SURRY POWER STATION, UNIT NO. 1

AMENDMENT TO FACILITY OPERATING LICENSE

Amendment No. 212
License No. DPR-32

AUGMENTED INSERVICE INSPECTION PROGRAM FOR HIGH ENERGY LINES OUTSIDE OF CONTAINMENT

MAIN STEAM AND FEEDWATER LINES - UNIT 2
SURRY POWER STATION
UNITS 1 AND 2

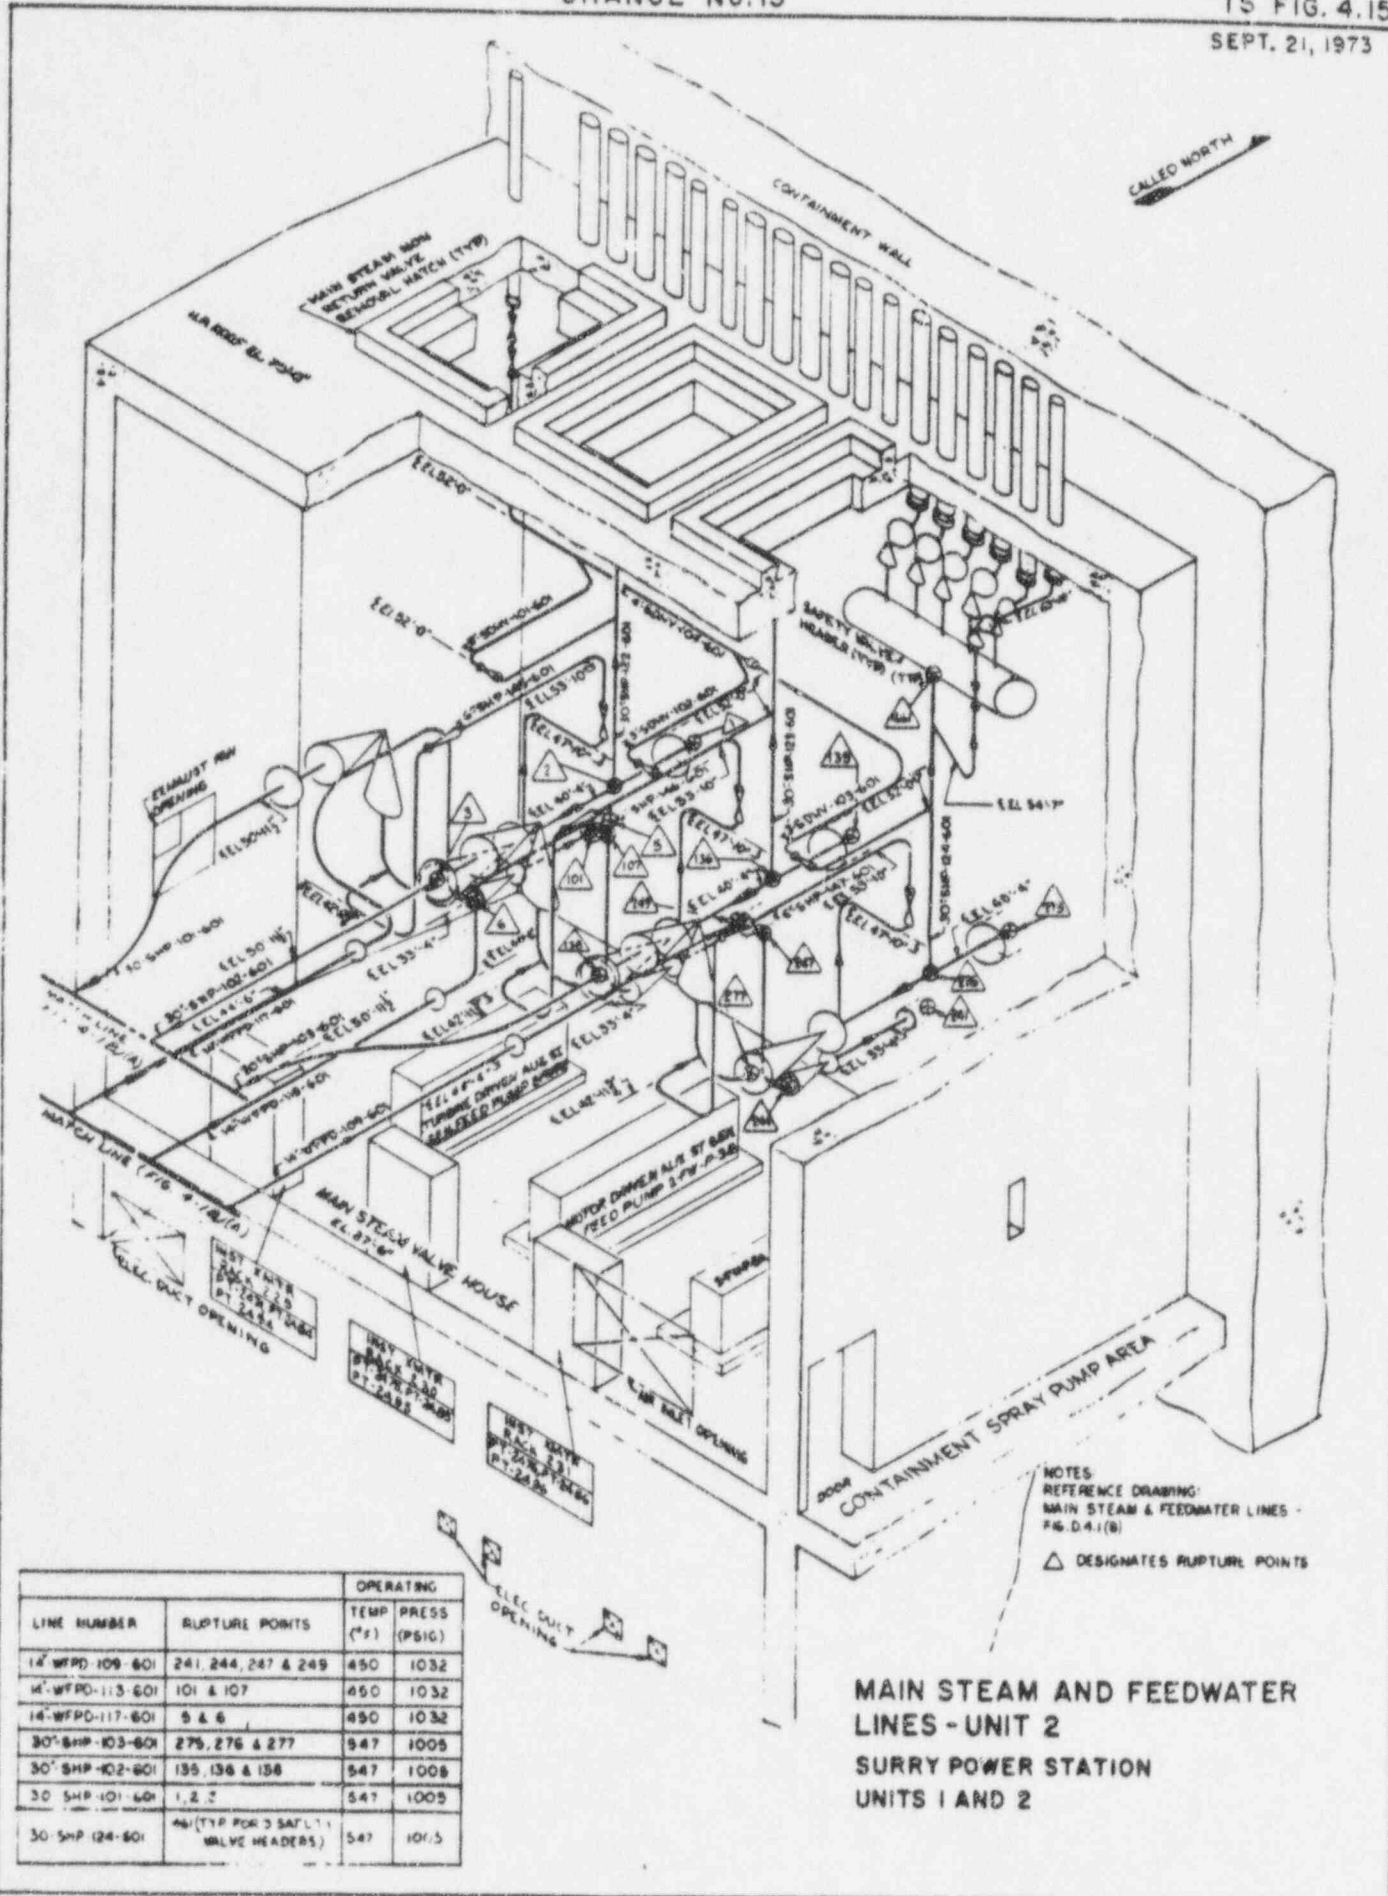
- A. For the 20 welds identified in TS Figure 4.15:
1. At the first refueling outage period a volumetric examination shall be performed with 100 percent inspection of welds in accordance with the requirement of ASME Section XI Code, Inservice Inspection of Nuclear Power Plant Components, to

- B. For all welds other than those identified in TS Figure 4.15:
1. Welds in the main steam lines including the safety valve headers and in the feedwater lines in the main steam valve house shall be examined in accordance with the requirements of subsection IWC of the ASME Section XI Code.
